ADDENDUM NO. 2

Raymore Activity Center: Project #17-229-201

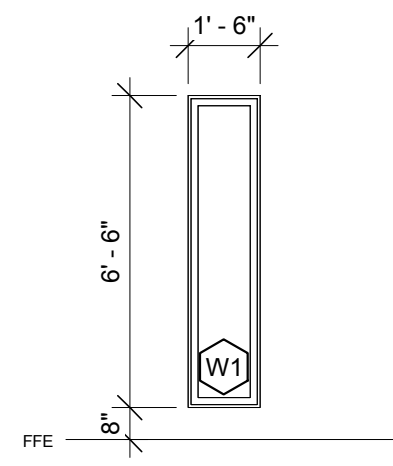
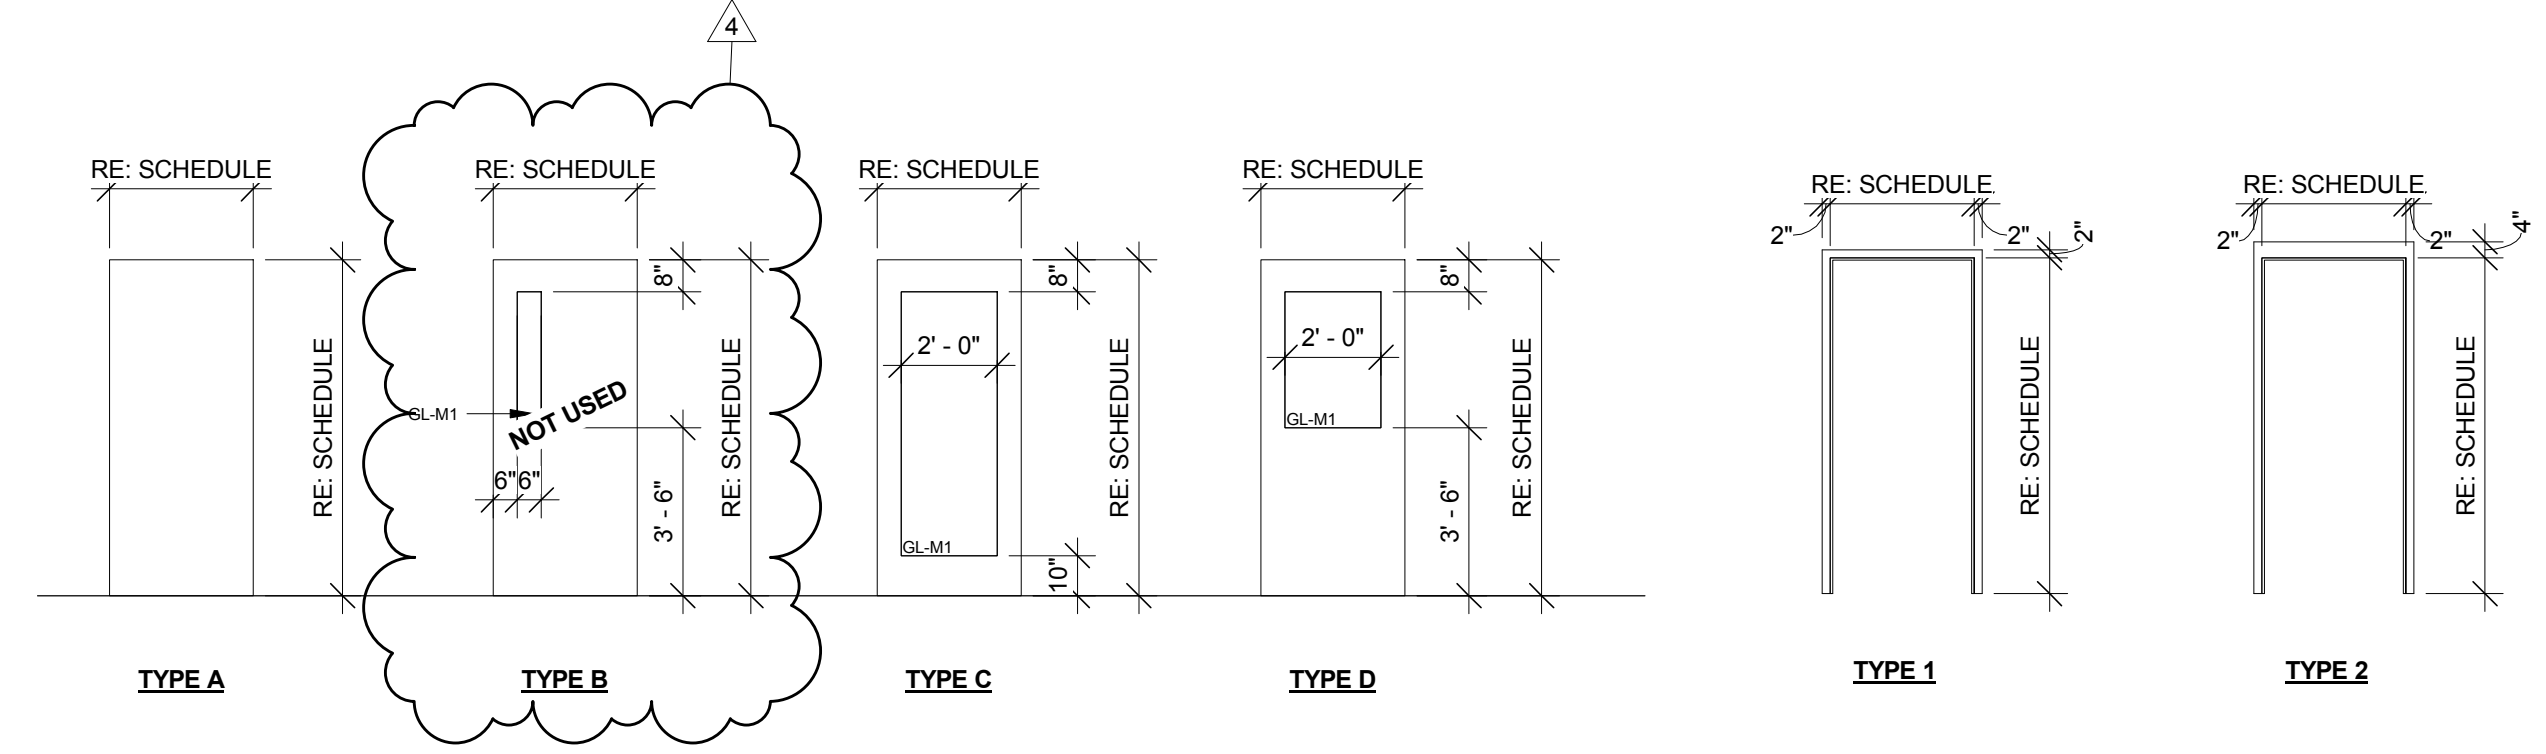
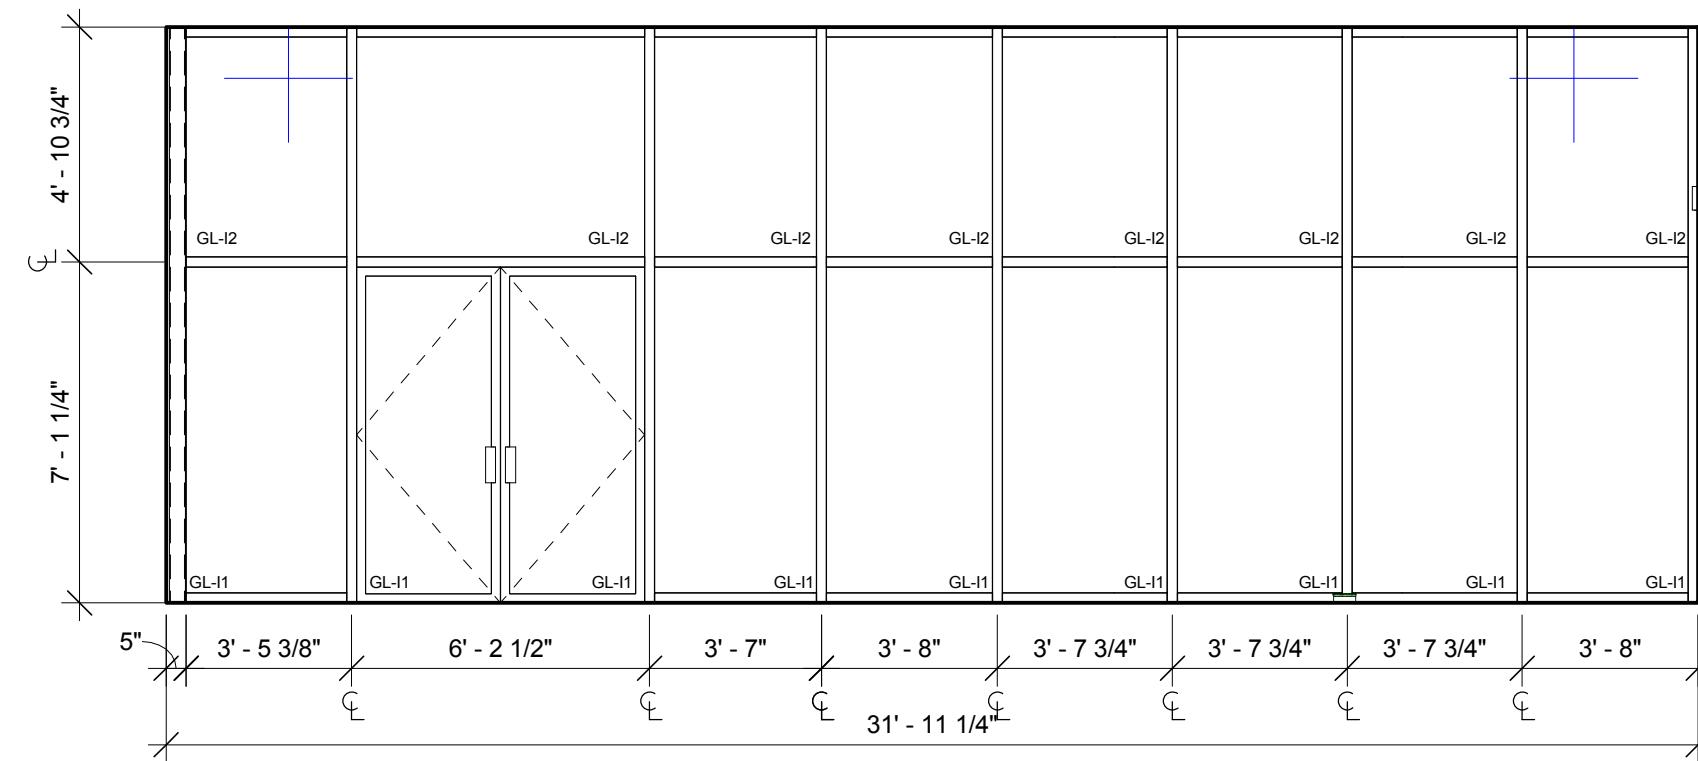
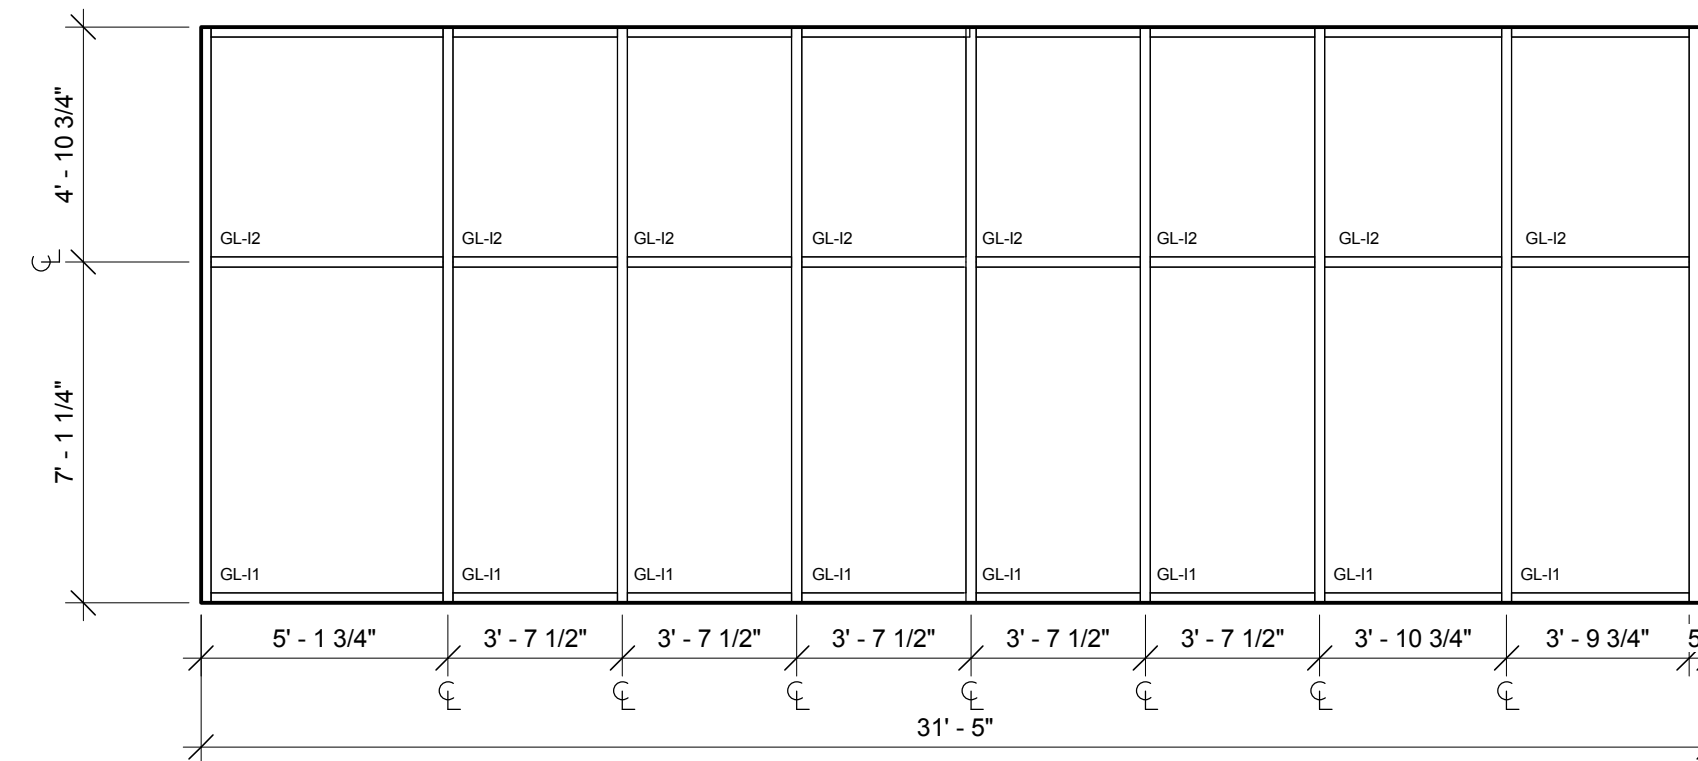
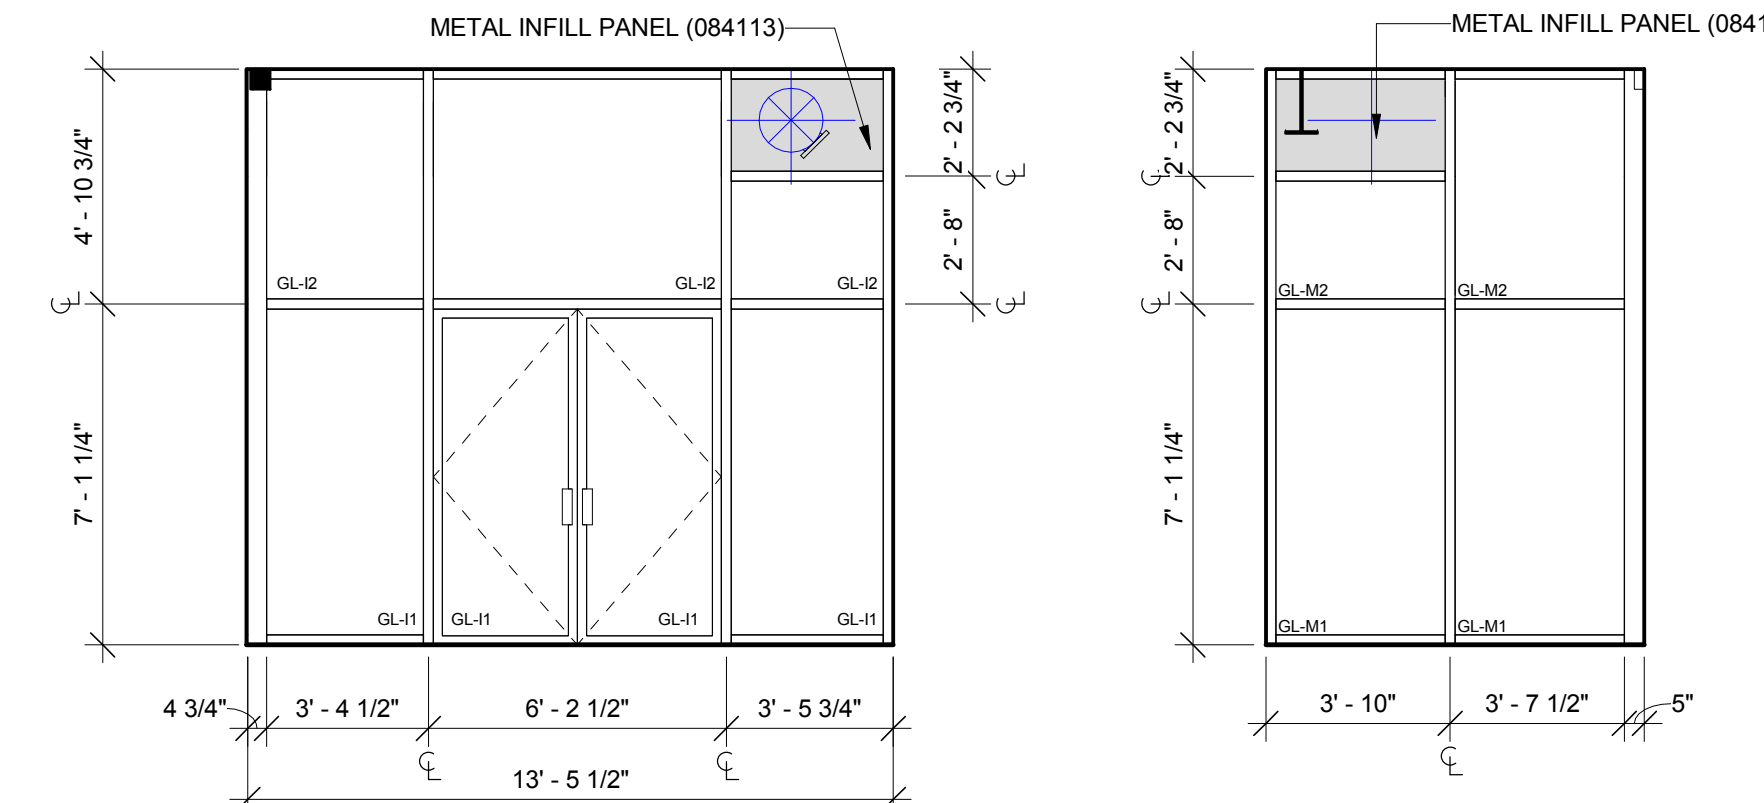
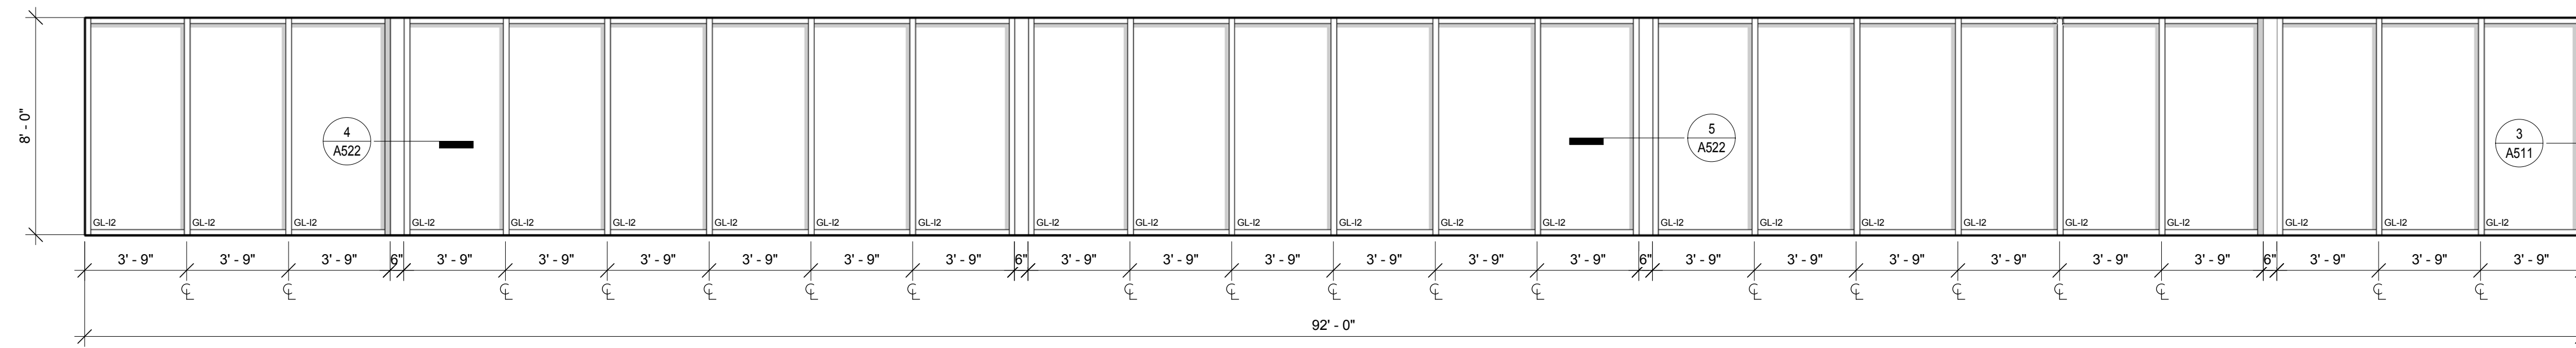
14. **Clarification:** Opening 112A is not on the door schedule of plans, but it is listed in finish hardware set 03.
 - a. **Response:** Door 104 at the Gymnasium should read 112A door 104 should not exist.

15. **Clarification:** There is no Door Type B noted in the door schedule.
 - a. **Response:** Door Type B on sheet A601 is not used in this project.
16. **Clarification:** In addendum 1 it mentions the asphalt walkway and gravel drive in questions 26, 30, and 35. There is still some confusion on whether these will be part of the bid, if so, will new drawings be provided to show the full extent of the walkway/drive and will a new bid form be provided that includes the new alternates for each?

- 1. A601 – DOOR AND STOREFRONT TYPES AND SCHEDULES (Replace sheet in its entirety with the attached)**
 - a. REVISED door schedule
 - i. Door 104 is now door 112A

- ii. Door 112A is door type A
 - iii. Door Type B is “not used”
- 2. E111 – LIGHTING RCP (Replace sheet in its entirety with the attached)**
 - a. Added keyed notes #6 and #7

E111

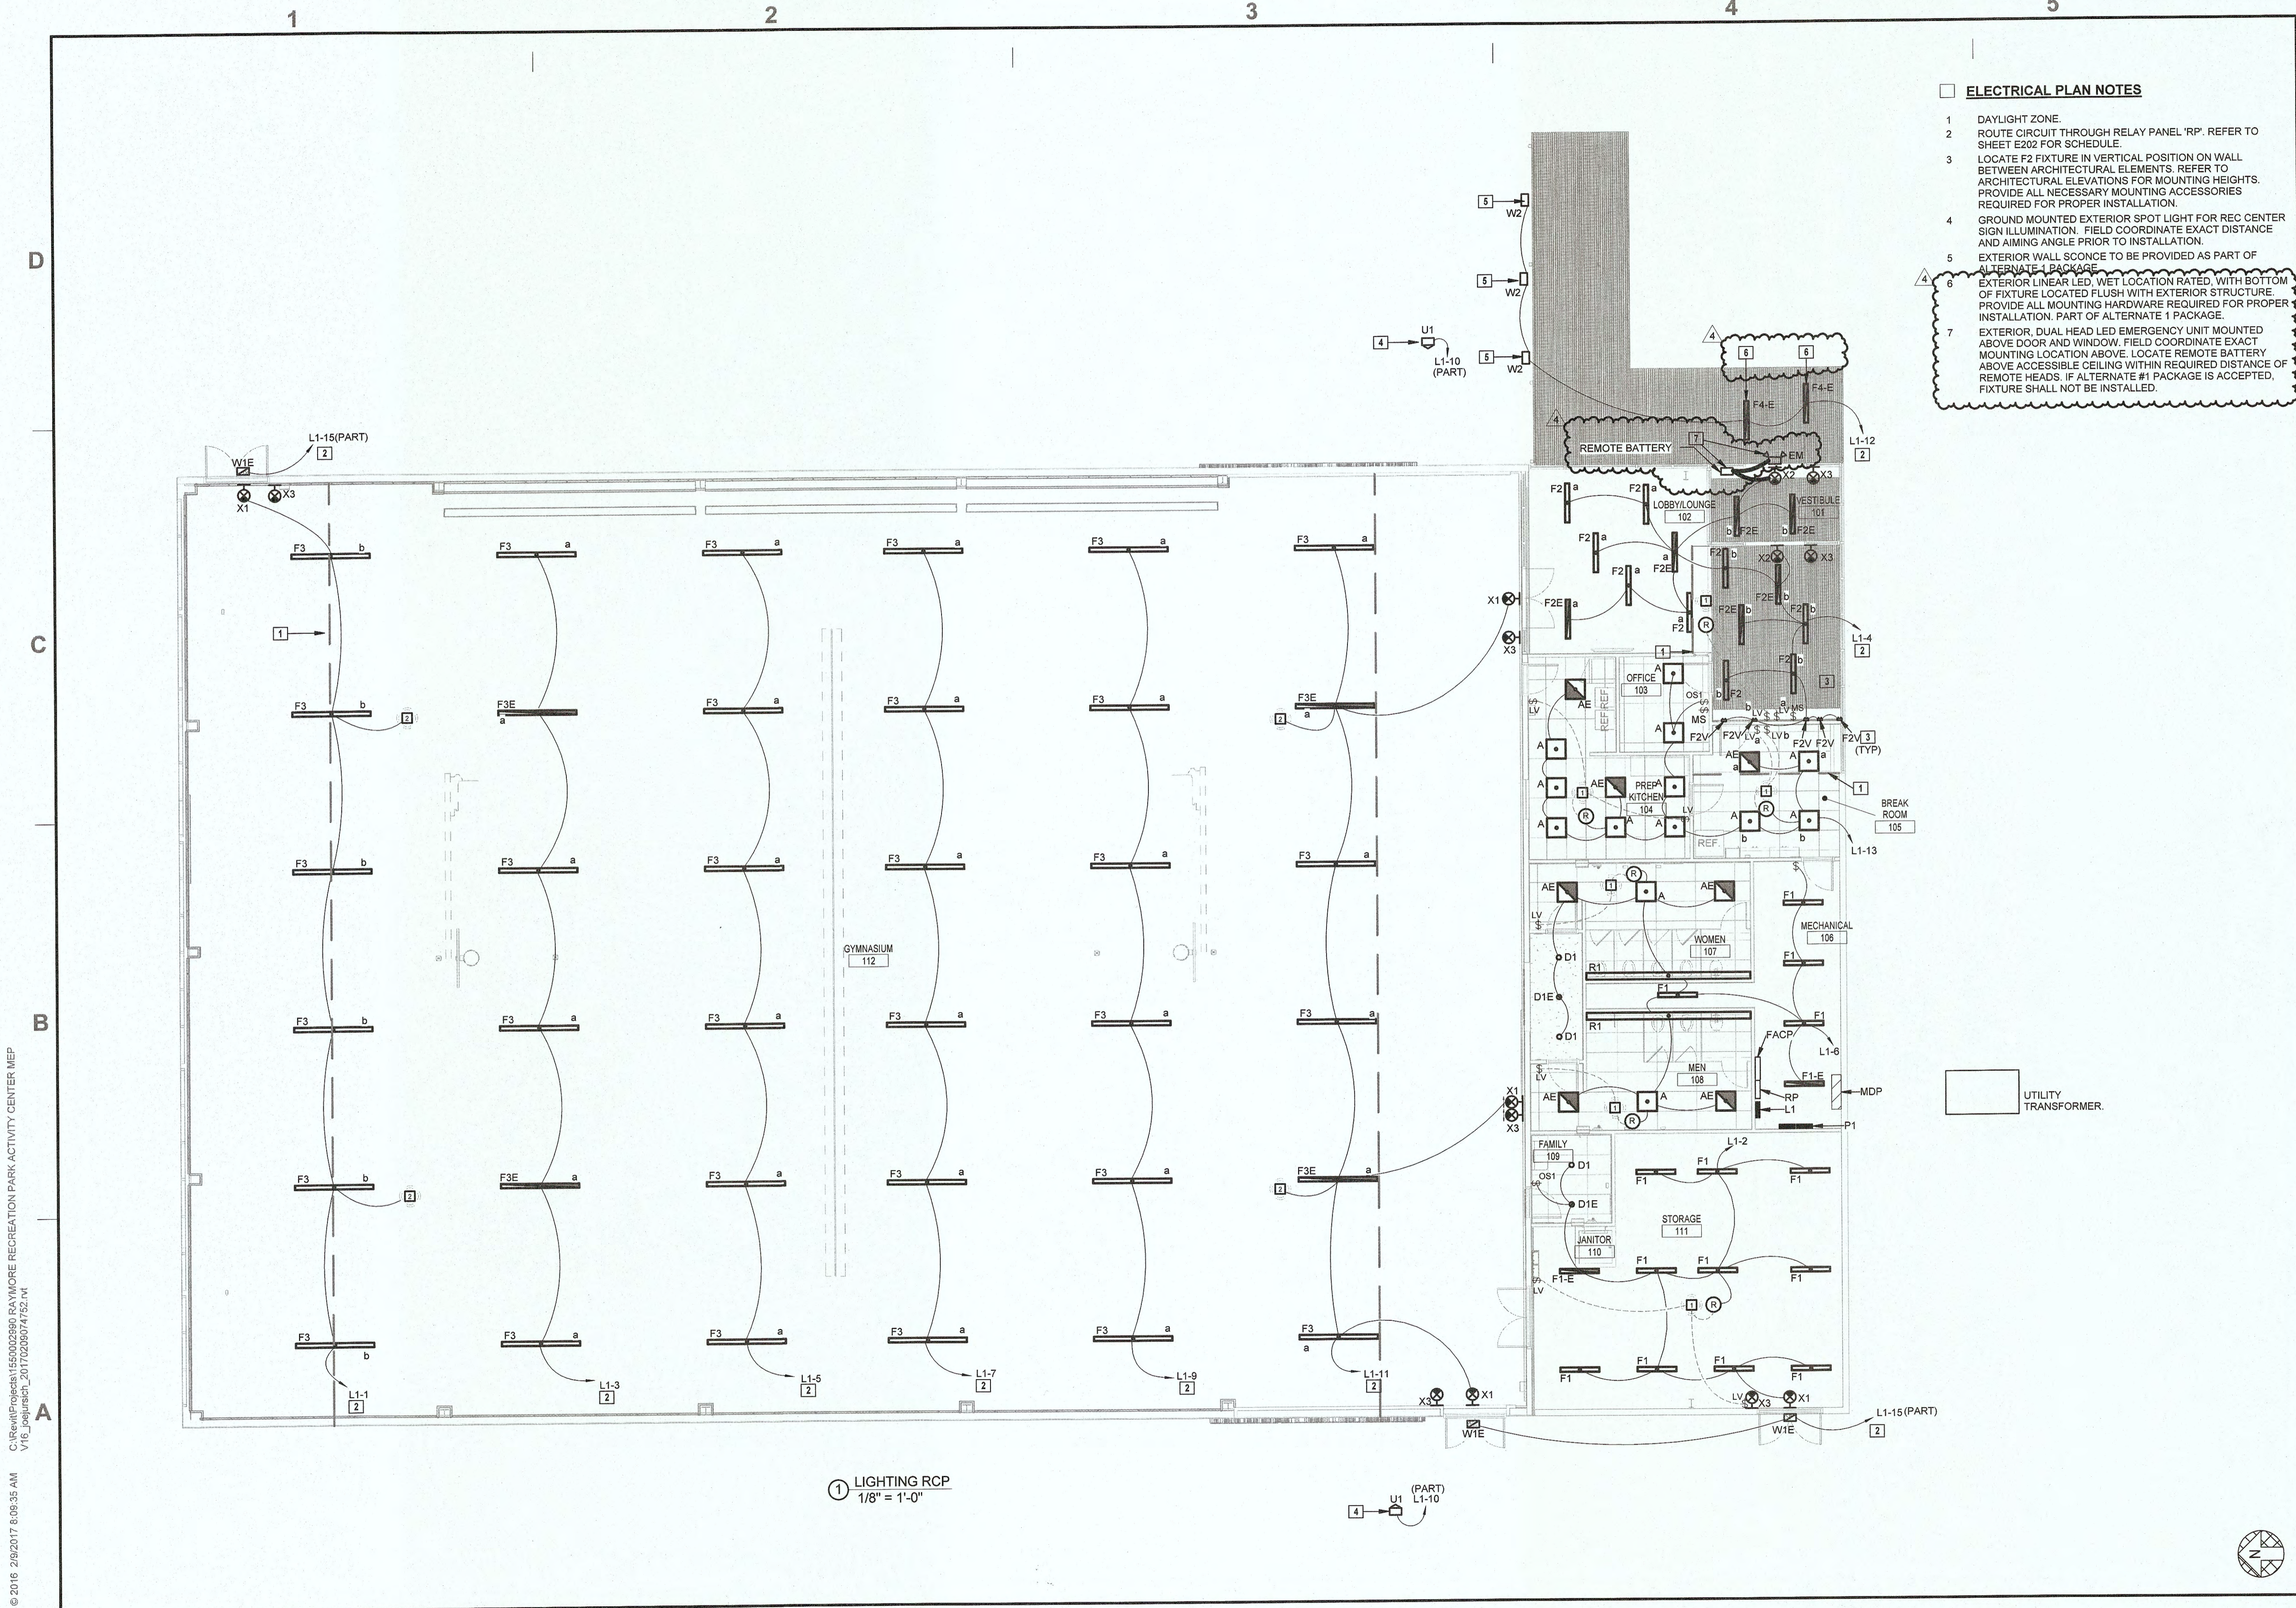
- b. Added emergency lighting fixture on exterior of building at main entrance. Provided with remote battery backup in vestibule.
- 3. E203 – ELECTRICAL SCHEDULES (Replace sheet in its entirety with the attached)**

- EXTERIOR, DUAL HEAD LED EMERGENCY UNIT MOUNTED ABOVE DOOR AND WINDOW. FIELD COORDINATE EXACT MOUNTING LOCATION ABOVE. LOCATE REMOTE BATTERY ABOVE ACCESSIBLE CEILING WITHIN REQUIRED DISTANCE OF REMOTE HEADS. IF ALTERNATE #1 PACKAGE IS ACCEPTED, FIXTURE SHALL NOT BE INSTALLED.
